# Wisconsin Department of Transportation

**Proposal #49: 7130-01-72, WISC 2016 189**  
**C Arcadia, STH 93**  
**Detloff Drive to STH 95**  
**STH 93**  
**Trempealeau County**

**7130-01-74, WISC 2016 190**  
**Centerville - Independence**  
**0.8 Miles North Junction CTH G**  
**STH 93**  
**Trempealeau County**

This is Addendum No. 01, which provides for the following:

Addendum No. 01  
 ID 7130-01-74  
 Revised Sheet 45  
 May 5, 2016

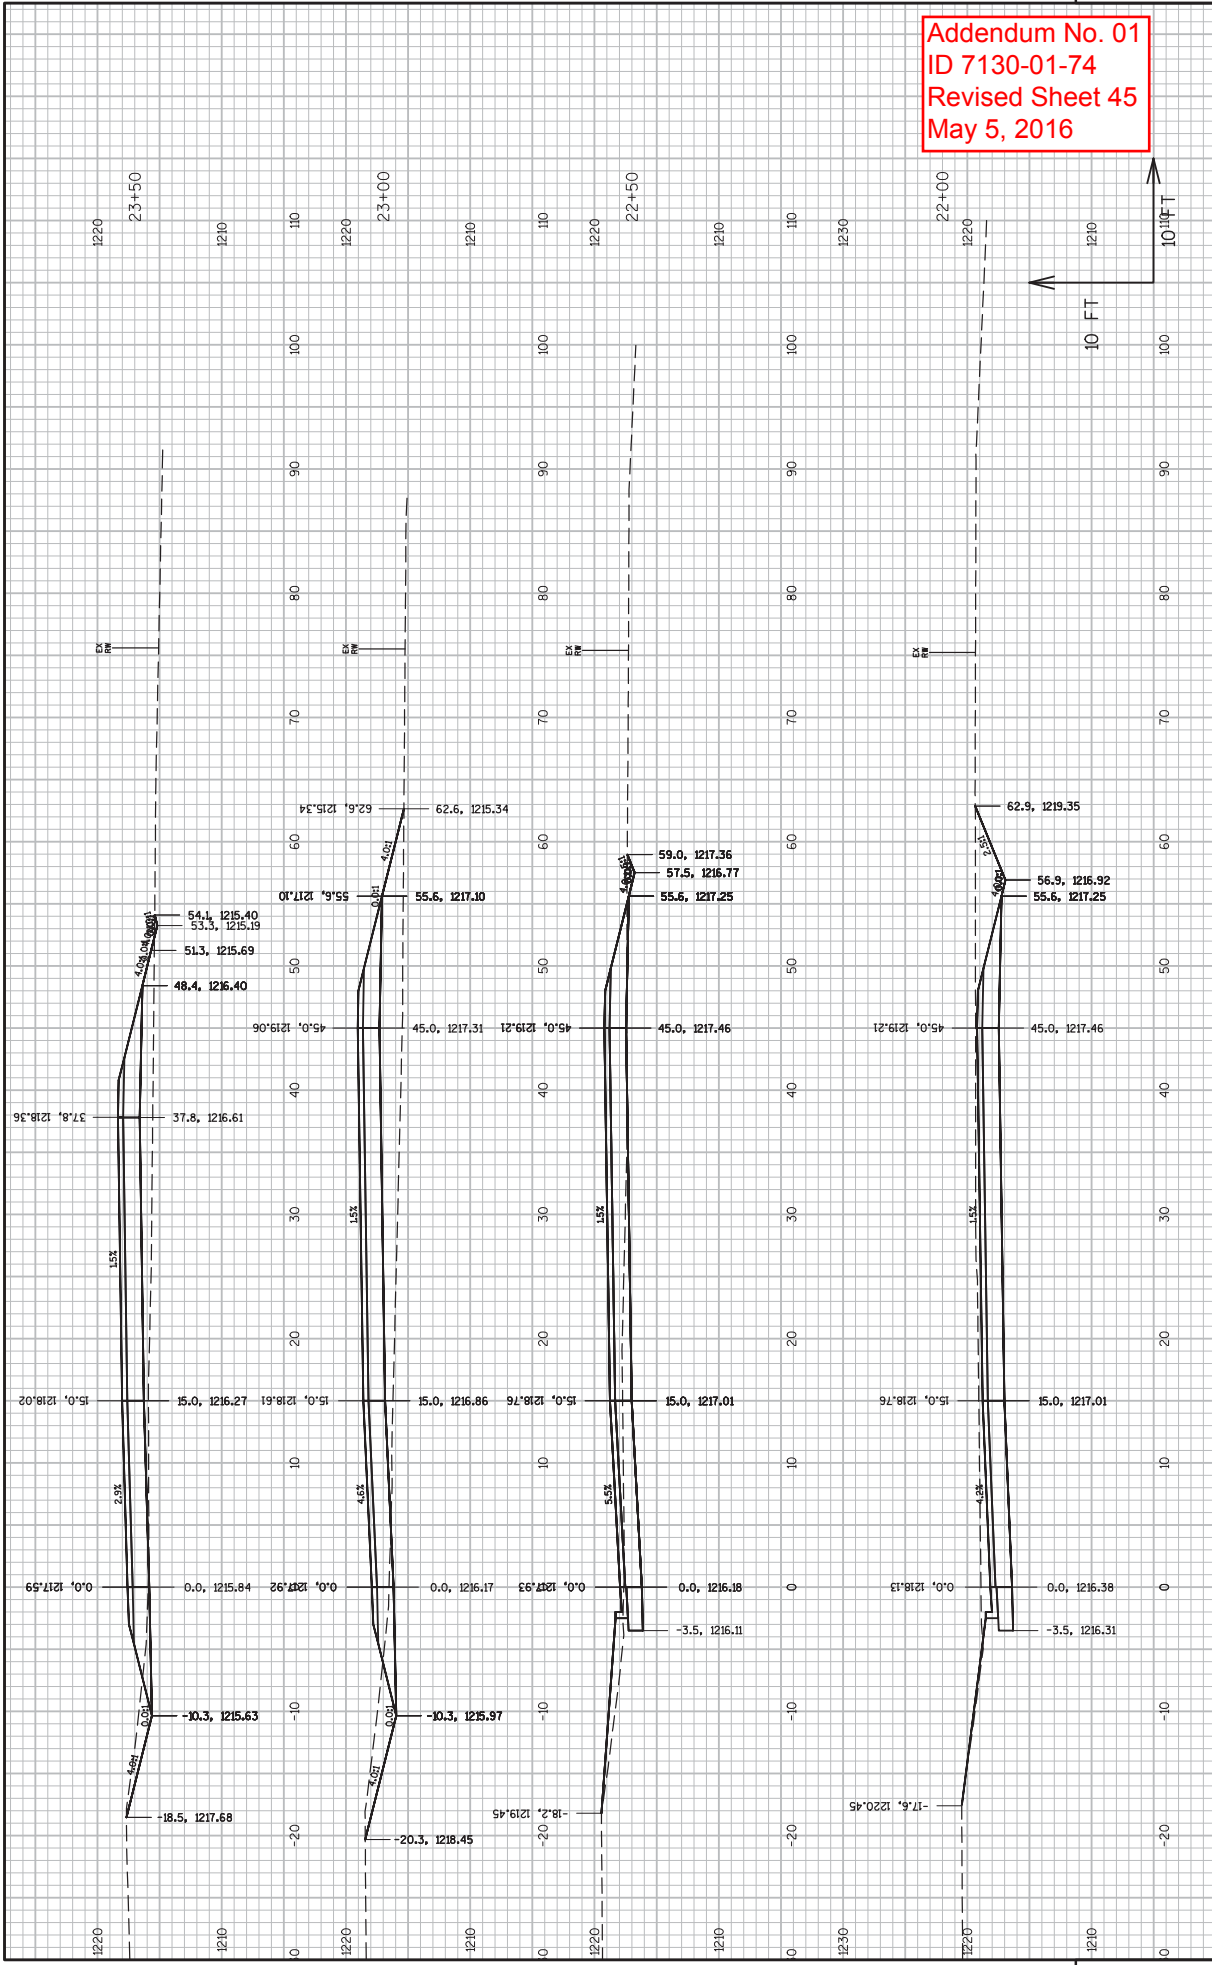
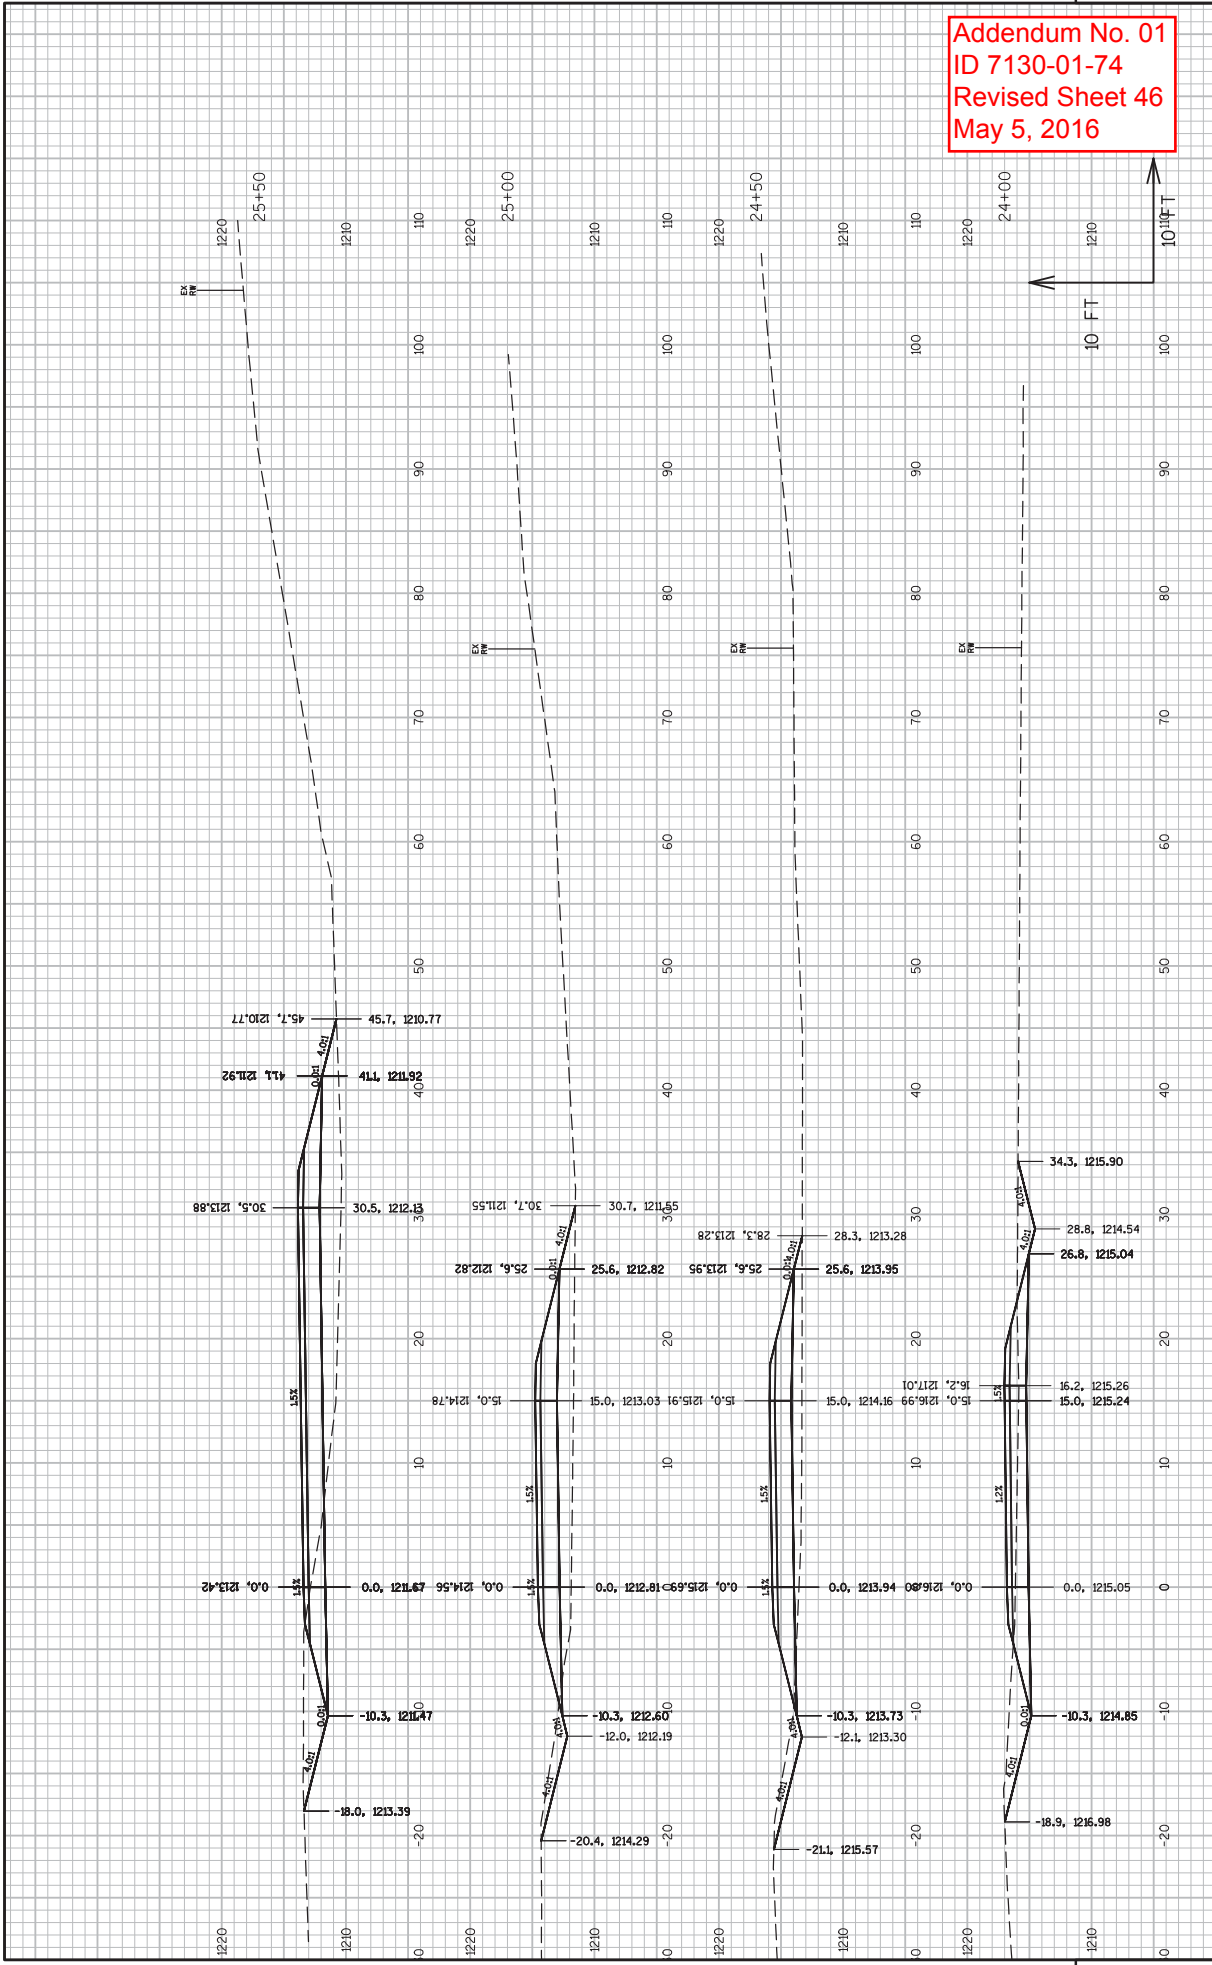
Revised Plan Sheets – ID 7130-01-74	
Plan Sheet	Plan Sheet Title (brief description of changes to sheet)
2	General Notes
3 – 4	Typical Sections (Sheets were blank in plan)
38	Earthwork
39 – 47	Cross Sections (Sheets were blank in plan)
